Service Bulletin TV Products

Model: KP-53XBR45, KP-61XBR48

No. 331

Subject: Part Number for Diodes D1214 & D1215 on the

GB Board

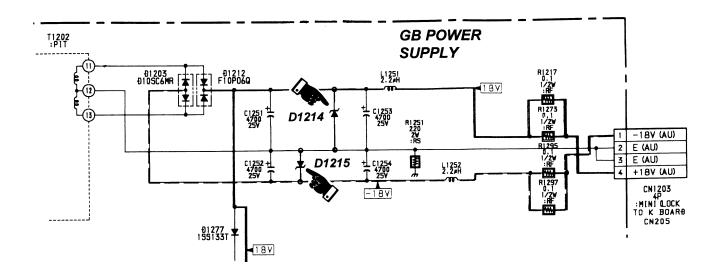
(****) Service Manual does not show, on the GB Board, or list diodes D1214 & D1215 on

the Schematic or Parts List.

Solution: Please add the information below to your Service Manual.

Reference No.	Description	Part Number
D-1214	RD27F-T7B2	8-719-119-17
D-1215	RD27F-T7B2	8-719-119-17
